From: Ryan Destro <rdestro@bmepec.com>
Sent: Friday, April 28, 2023 2:33 PM
To: Stephen Ersteniuk; Kevin Wilson; Jennifer Miranda; Mark Cholach; Chris Martin; Stephen Schultz
Cc: Aaron Beyler; Mark Williams; Matthews, David; Prattico, Michael; Tom Danks; Andrew Spencer
Subject: RIT Research Building (Updated SUP Plans)
Attachments: RIT Research Building (Updated SUP Site, Grading & Utility Plans)_04-28-23.pdf

Yesterday (4/27), we (BME Associates and RIT) met onsite with the Henrietta Director of Building and Fire Protection, the Fire Marshal, and the Fire Chief to review the proposed fire access route(s) for the new RIT Research Building. Per input received from the individuals noted above, we have made the following updates to the Special Use Permit plans for Building Height (attached for reference):

Project Name
RIT Research Building

SPECIAL USE PERMIT

Sheet Title
SITE PLAN

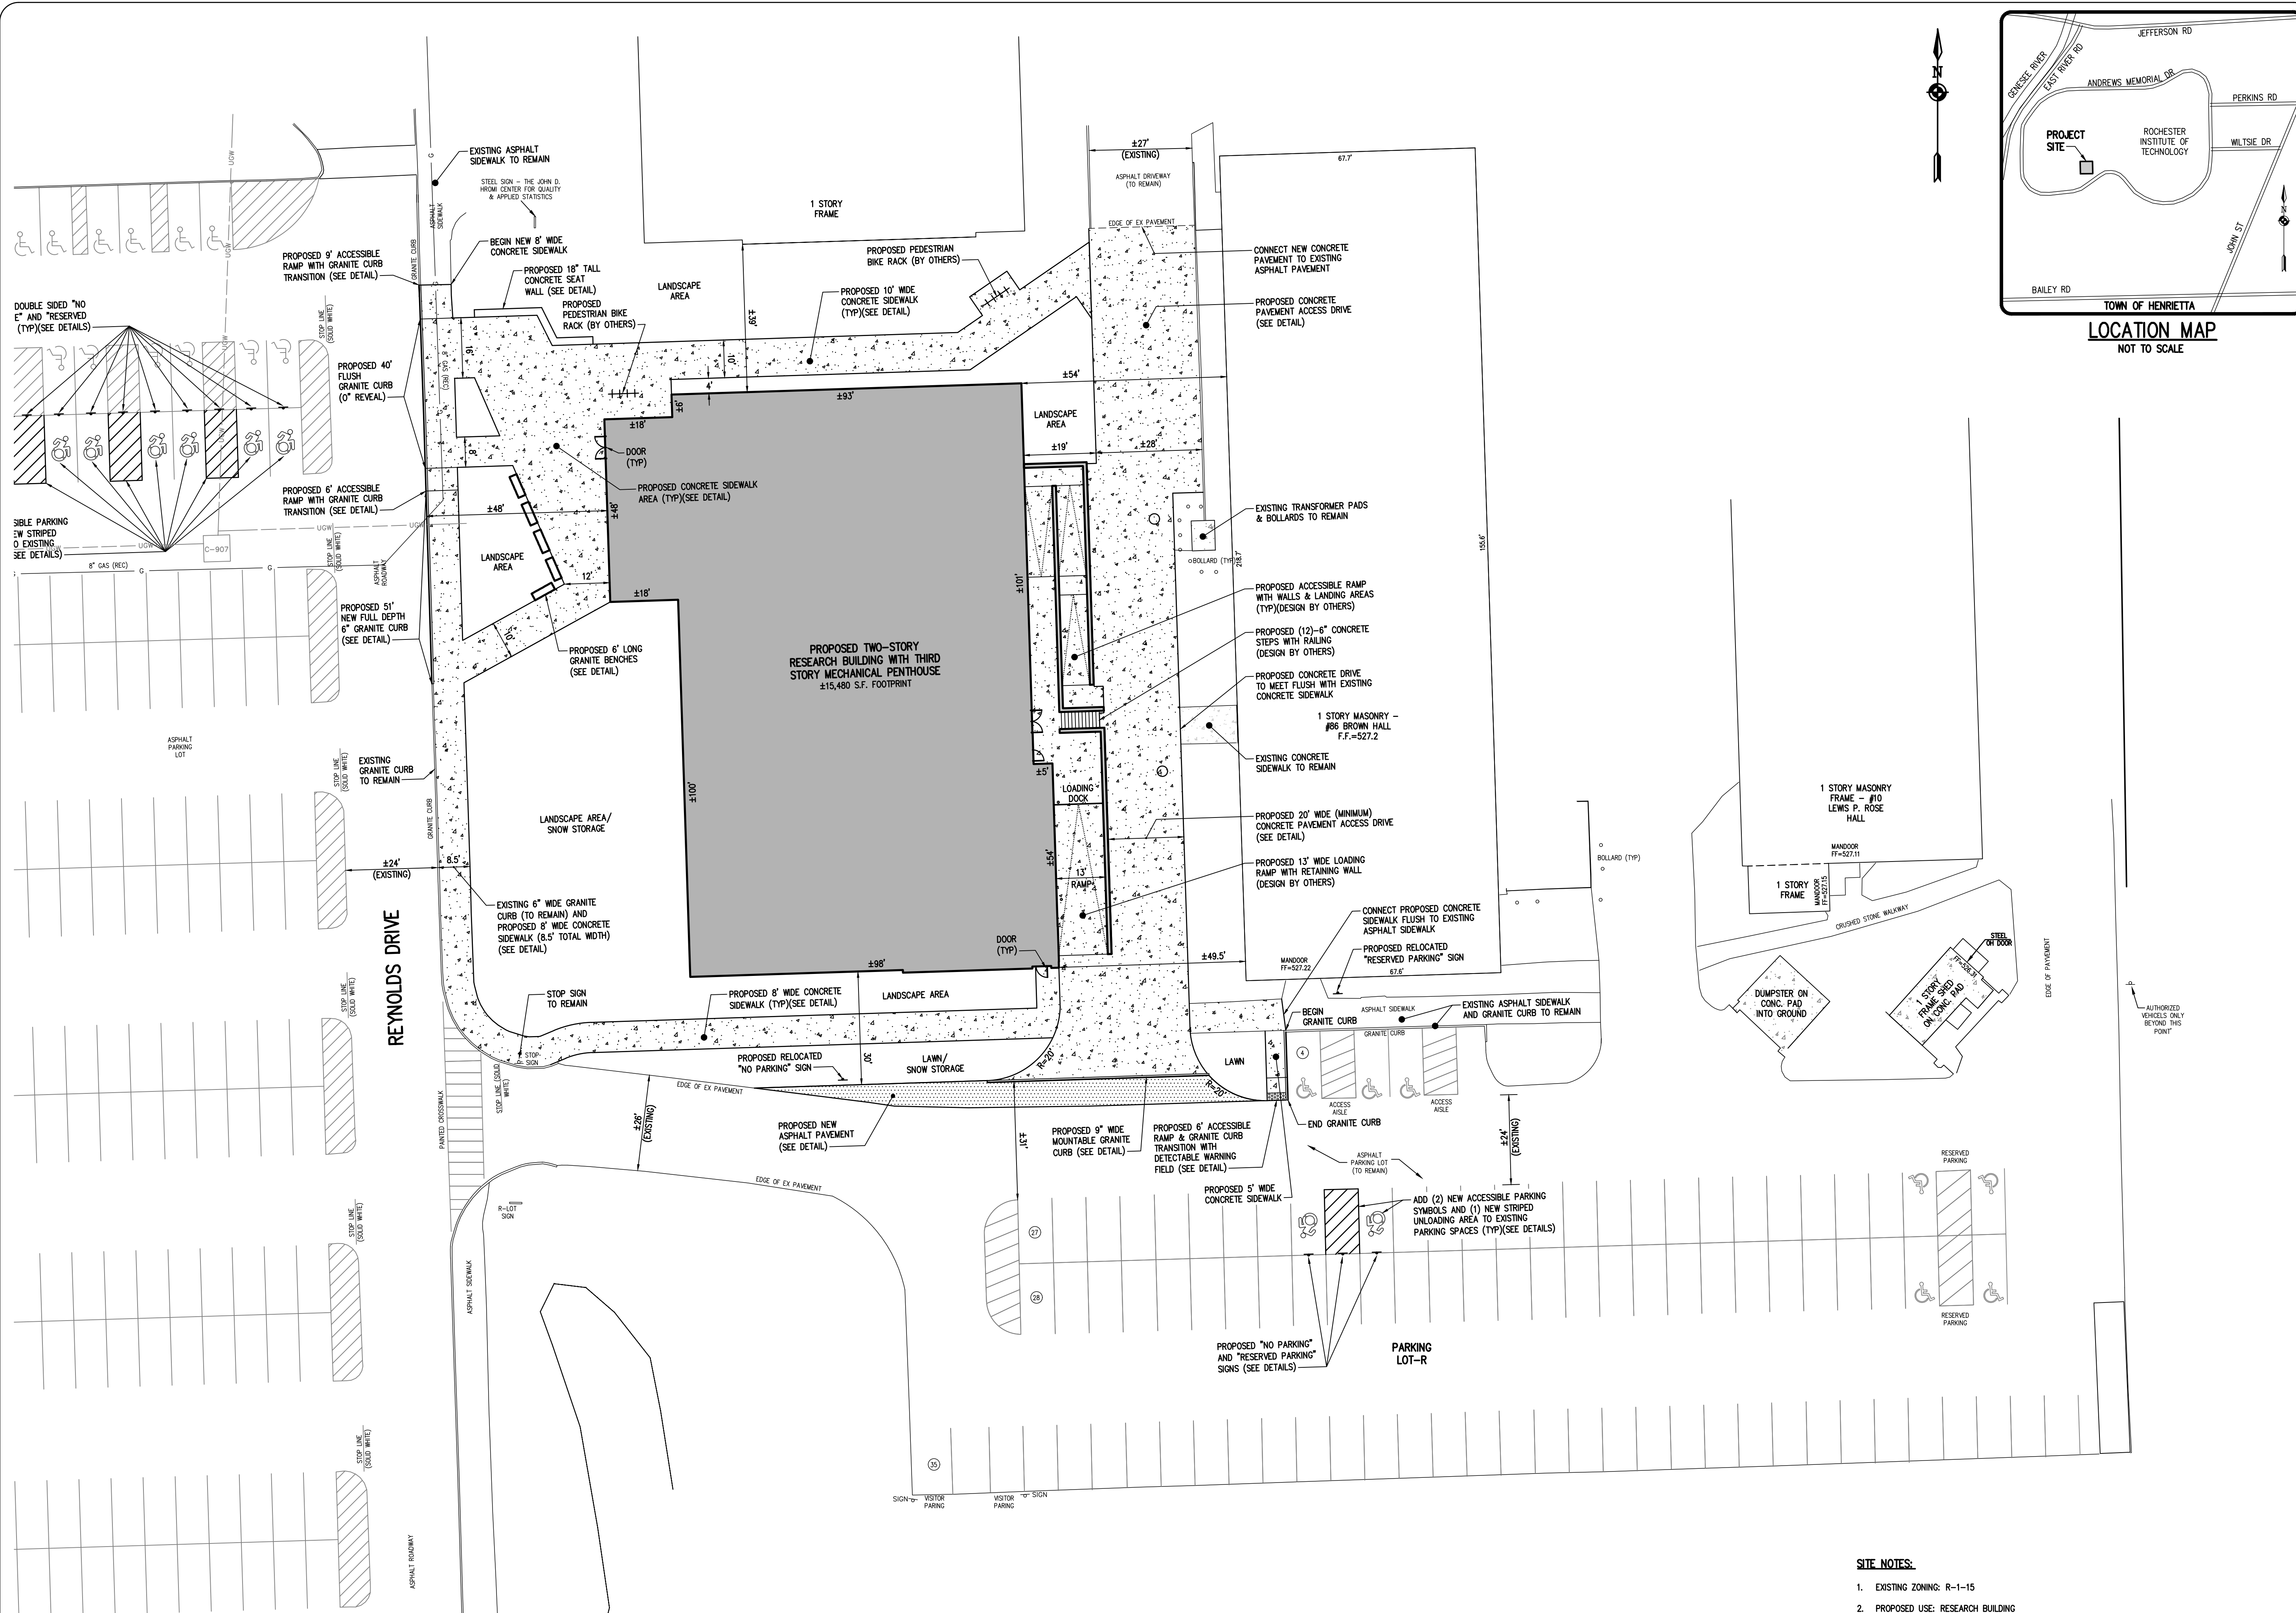
- The concrete pathway along the northern side of the proposed Research Building has been increased in width from 8' wide to 10' wide (see attached Site Plan, dwg #01 for reference).
- The proposed Fire Department Connection (FDC) is now shown on the Utility Plan (dwg #03 attached for reference) on the southern face of the building, near the eastern corner. This places the FDC adjacent to the southern Aerial Fire Apparatus Access Road.
- A new hydrant is now proposed on the Utility Plan (dwg #03 attached for reference) adjacent to the south face of the new Research Building and within 100' from the proposed FDC location.
- Also – as noted in during our site visit, RIT will be relocating the temporary modular structures from the paved access route on the east side of Brown Hall in advance of the new Research Building.
